ADDENDUM NO. 1

Additions & Renovations to Pleasant Run Elementary School
1800 North Franklin Road
Indianapolis, IN 46219

PROJECT: PLEASANT RUN ELEMENTARY SCHOOL RENOVATION & ADDITION

PROJECT NO: 2020061

DRAWING NUMBER
C702

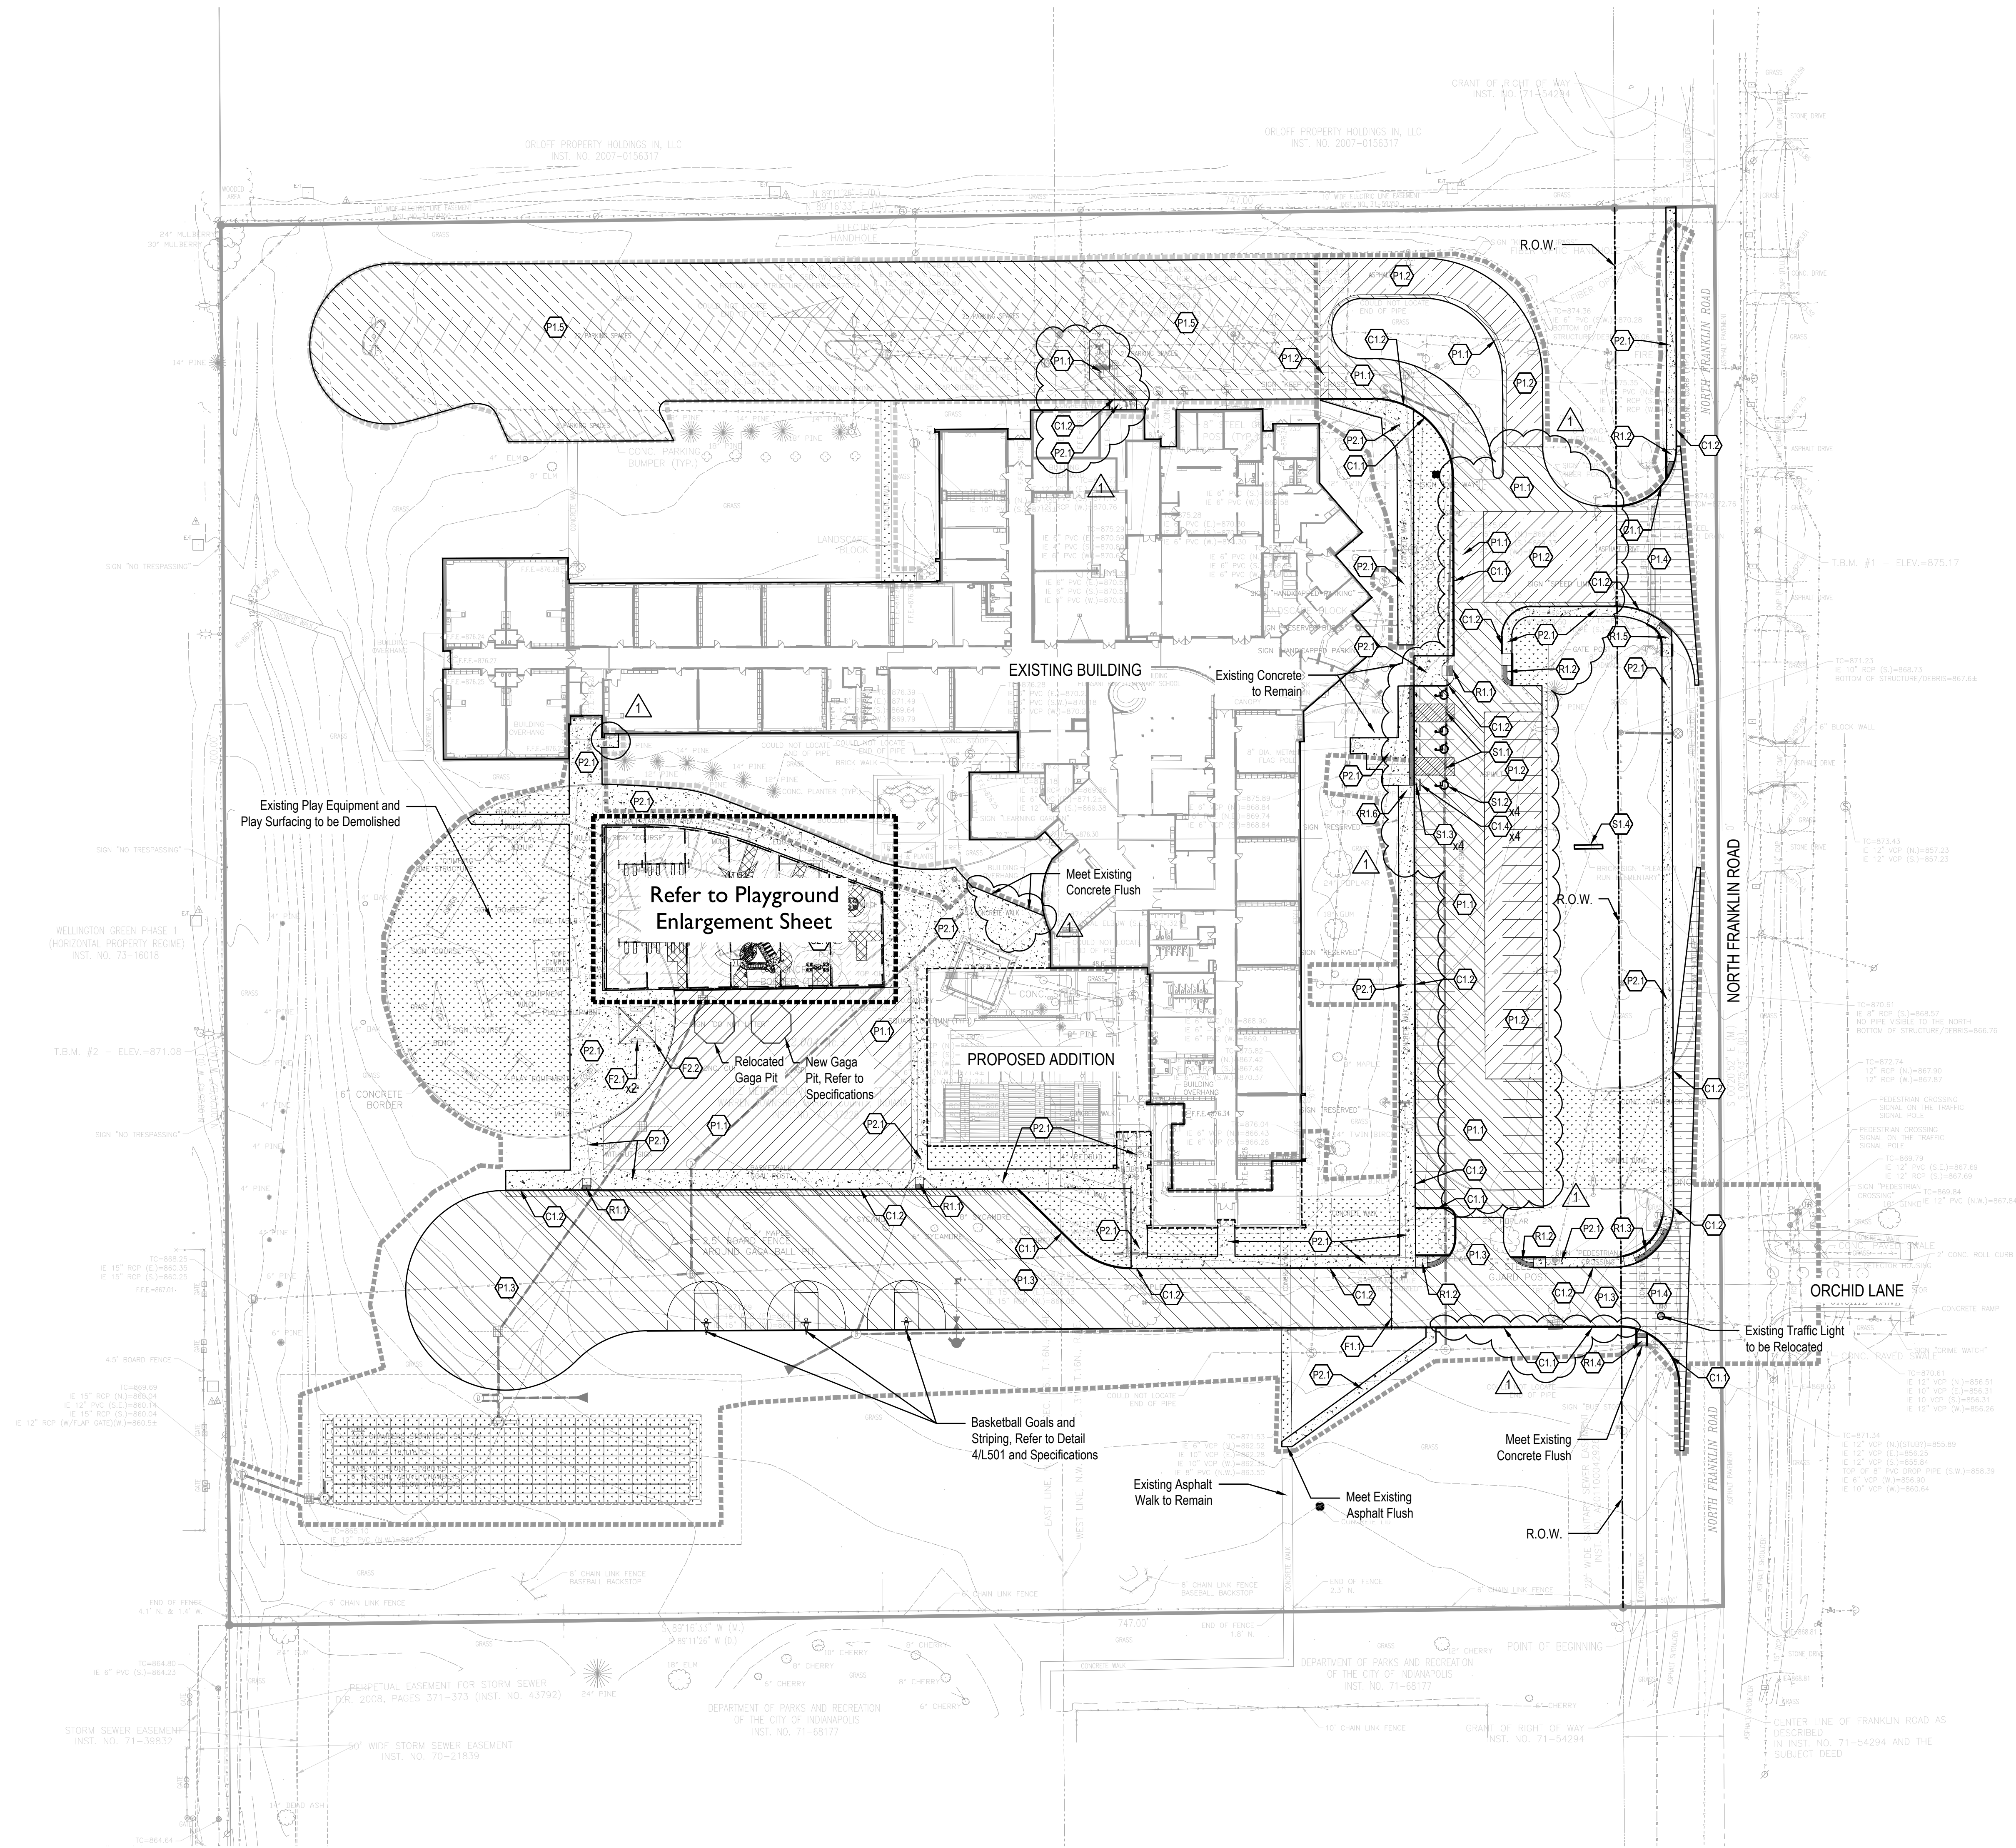
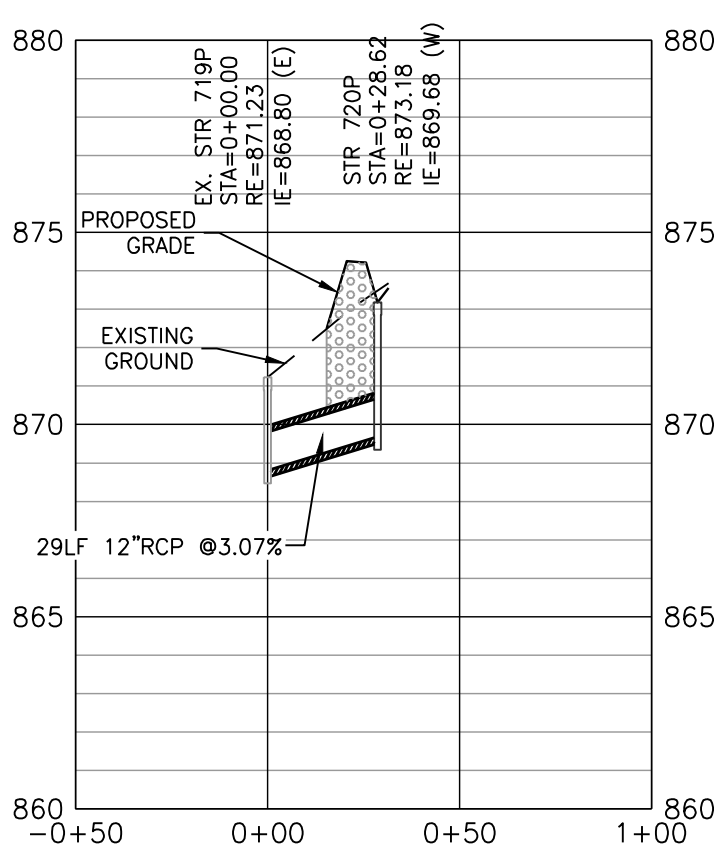
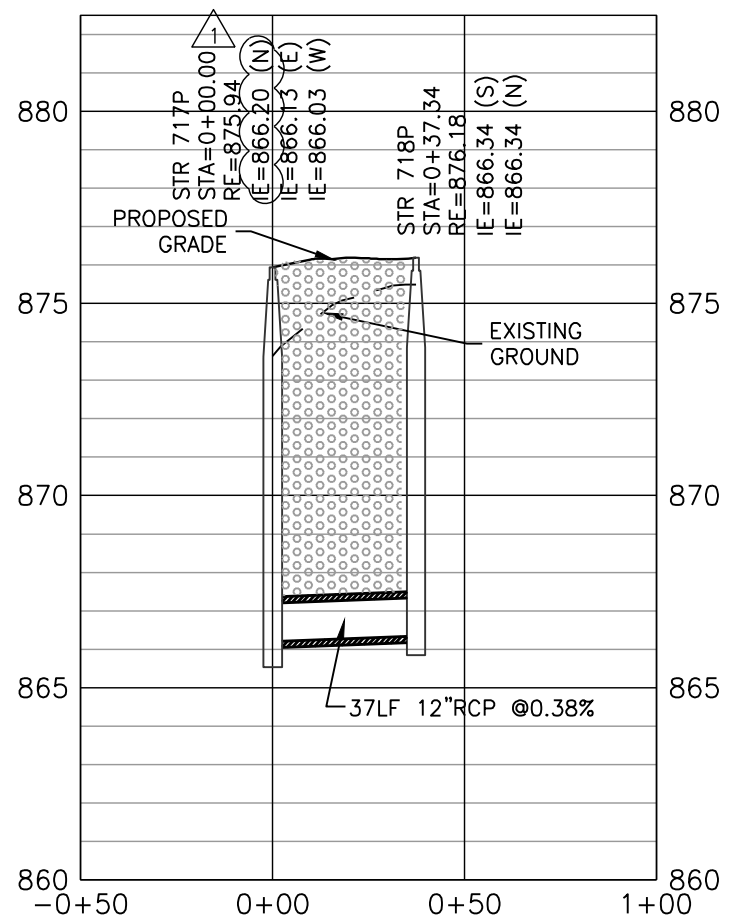
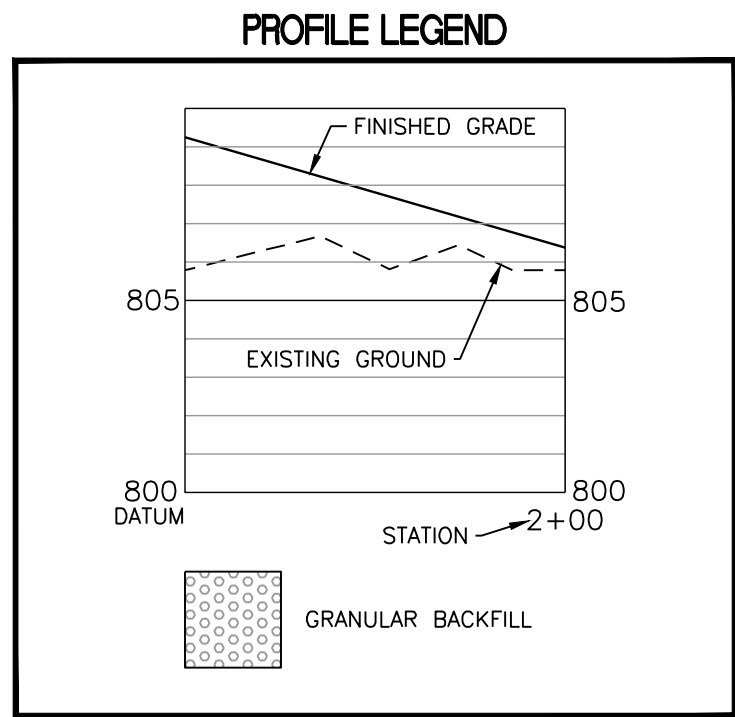
8. C702 Storm Sewer Plan and Profiles
 - a. Revise pipe invert at structure 717P.
9. L101 Materials and Notes Plan
 - a. Materials Plan edges of pavements and curbs have been updated.

DRAWING NUMBER
L210

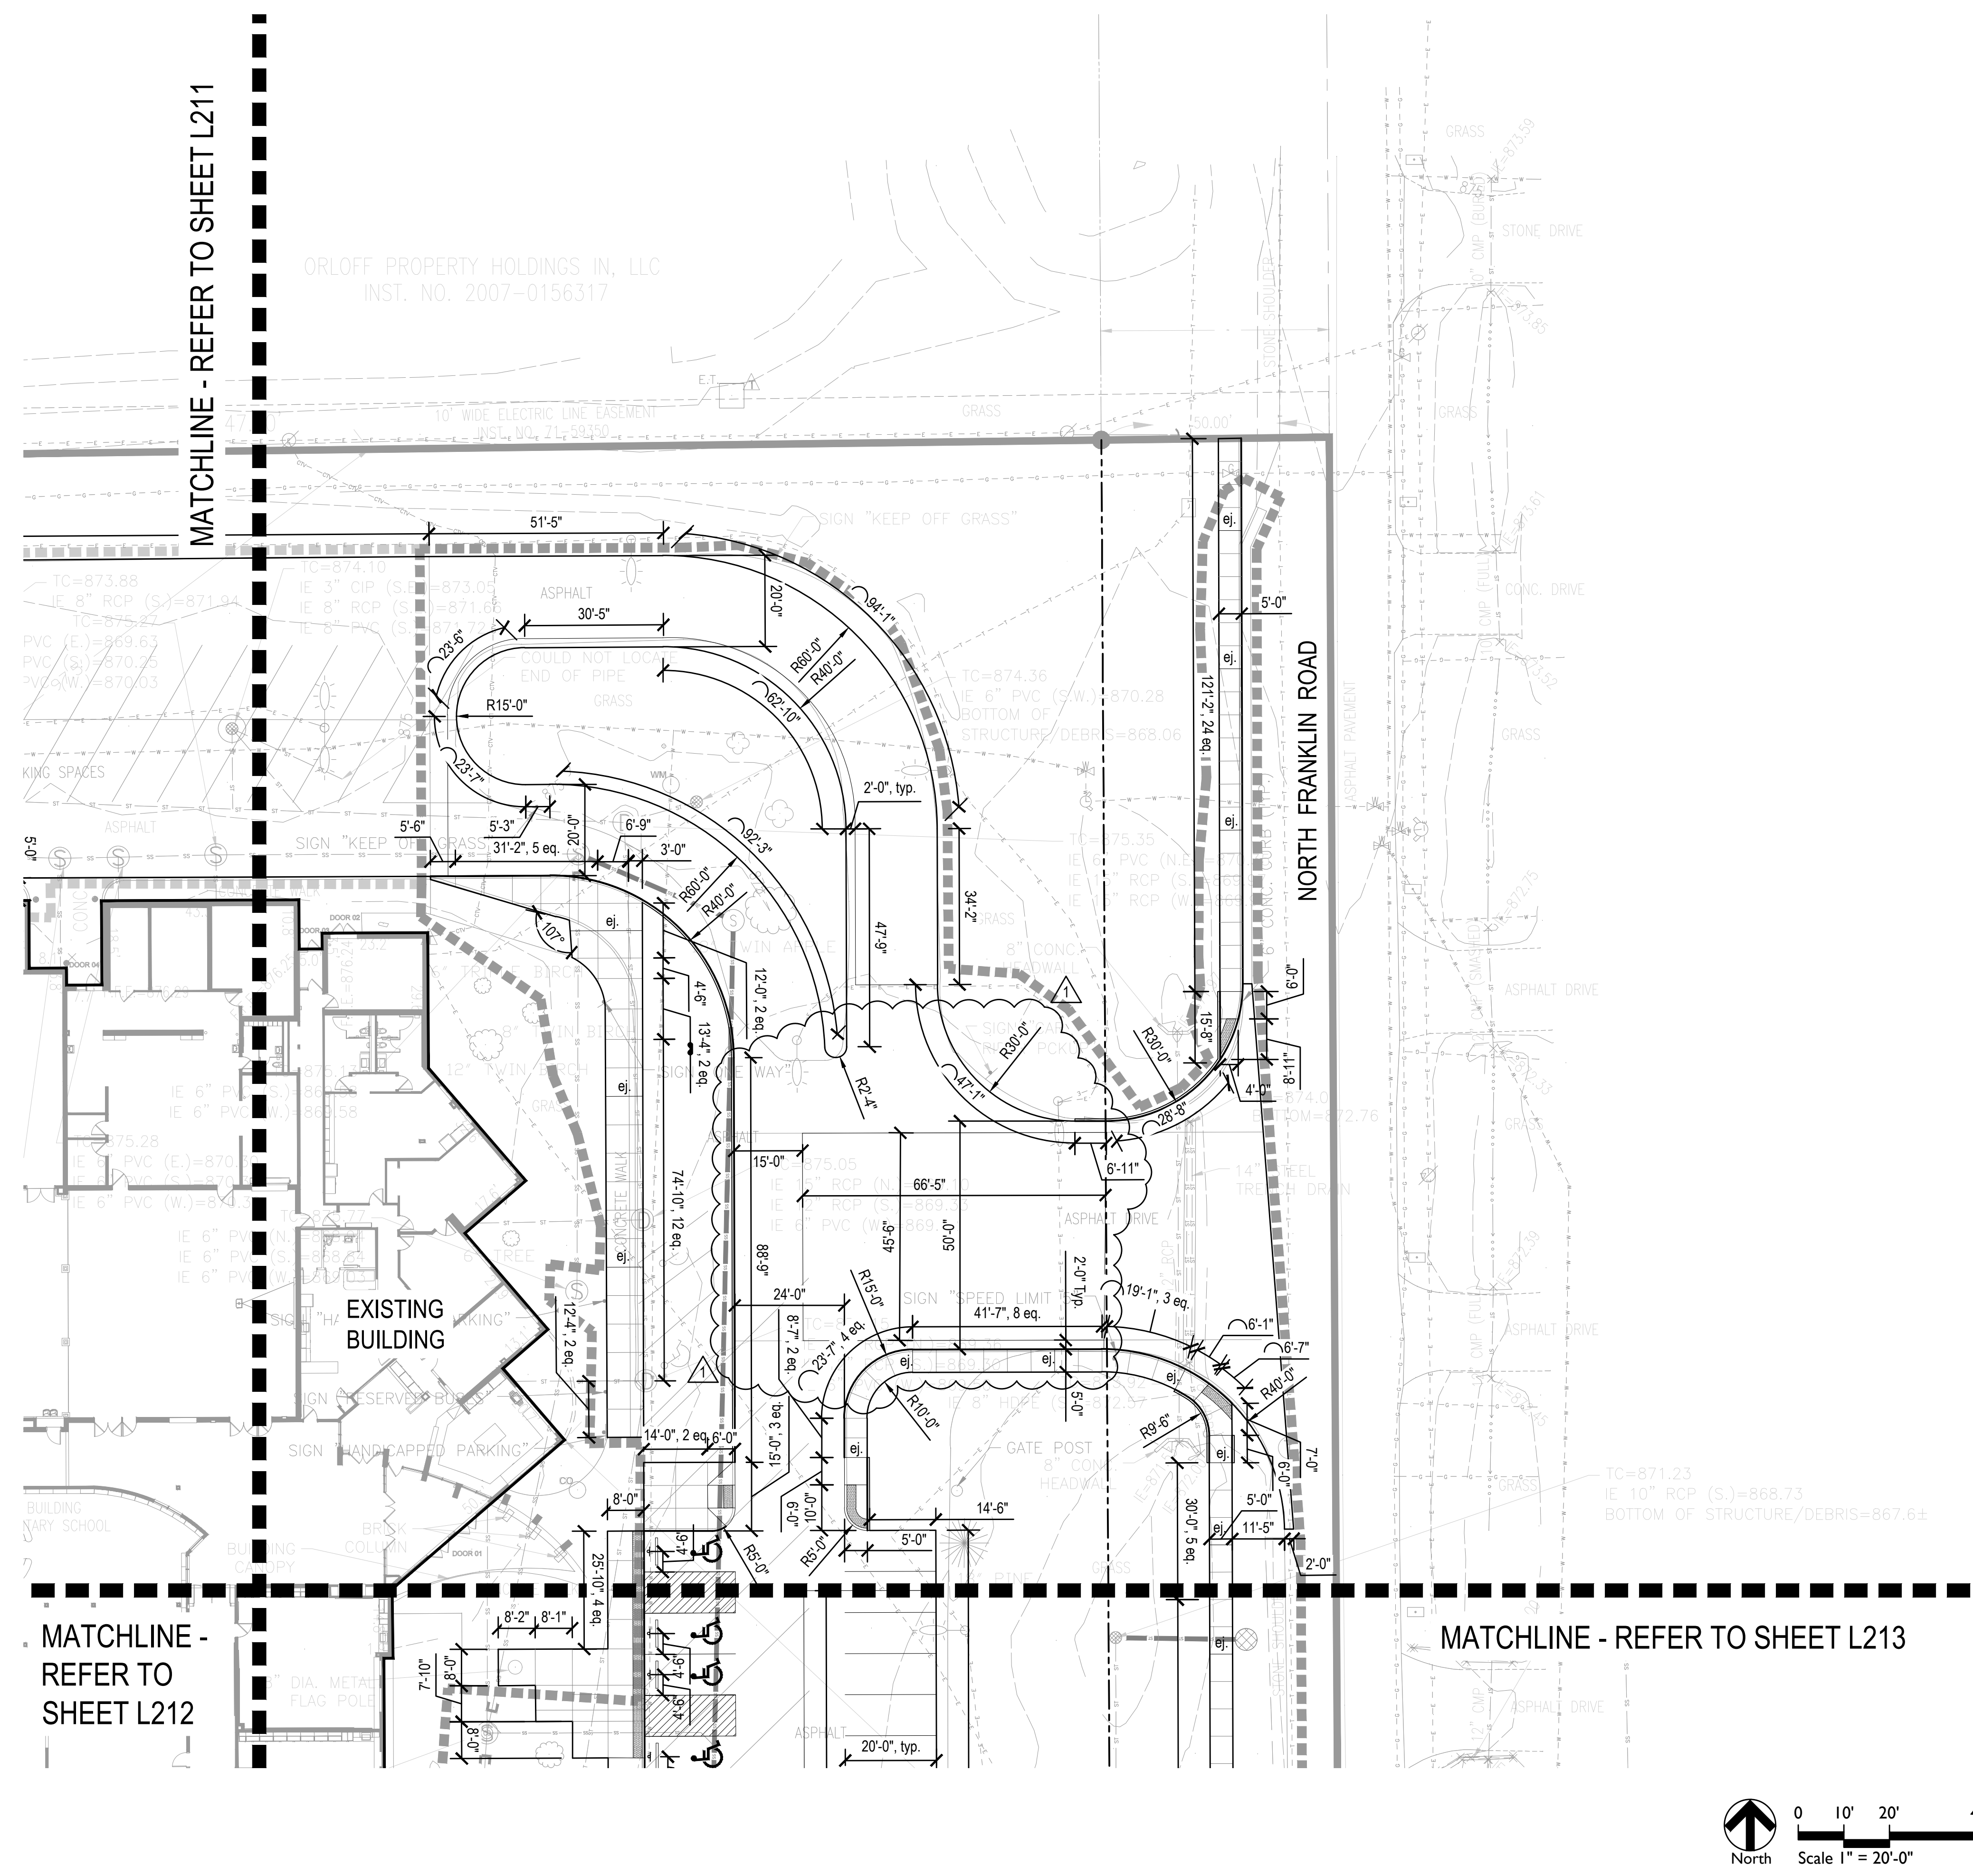
- 10. L110 Playground Enlargement
 - a. Playground Enlargement has been updated to clarify locations or Concrete Curbing.
- 11. L210 Layout Plan Enlargement
 - a. Layout of edges of pavements and curbs have been updated.
- 12. L211 Layout Plan Enlargement
 - a. Layout of edges of pavements and curbs have been updated.
- 13. L212 Layout Plan Enlargement
 - a. Layout of edges of pavements and curbs have been updated.
- 14. L213 Layout Plan Enlargement
 - a. Layout of edges of pavements and curbs have been updated.
- 15. L500 Site Details
 - a. Detail 10 Engineered Wood Fiber Play Surface updated for clarity.
